## COMMITTEE OF EXPERTS ON THE TRANSPORT OF DANGEROUS GOODS AND ON THE GLOBALLY HARMONIZED SYSTEM OF CLASSIFICATION AND LABELLING OF CHEMICALS

### PERFORMANCE OF PACKAGINGS INCLUDING IBCS

Comments on ST/SG/AC.10/C.3/2008/100

Date of manufacture of inner receptacles of composite IBCs

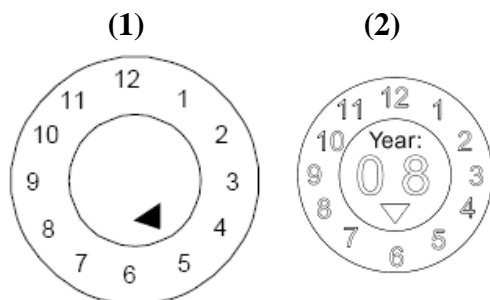
1. The expert from Germany has studied the proposal from the International Confederation of Plastics Packaging Manufacturers (ICPP) regarding the marking of inner receptacles of composite IBCs and can support this proposal on principle. However, looking to the given example of the “clock” and realising what are widely-used technical solutions in the blow moulding process this proposal can lead to severe misunderstandings during inspections. Usually the “clock” in the blow mould is constructed in such a manner that the exterior ring indicating the month of manufacture is firmly attached to the blow mould and the inner plate with the pointer or arrow indicating the year of manufacture is a rotating disc. Taking the given example of ICPP and turning notionally the pointer against the “12” as an indication that December is the month of manufacture, the year of manufacture could be read untruly as “80” by any controlling body. In 2010 the year of manufacture could be read as “01” instead of “10” dependent on the position of the pointer, with the consequence that controlling bodies could prosecute the user due to violation of the requirement in 4.1.1.15. Therefore, in our view it is necessary to amend the ICPP proposal in order to avoid such misunderstandings.

2. **Proposal 1:** Amend the proposal of ICPP as follows:

The date of the manufacture of the plastics inner receptacle may alternatively be marked on the inner receptacle in a different place close to the remainder of the marking in such a manner that the meaning of the marking for the date of manufacture is non-interchangeable. As example, an appropriate method is:
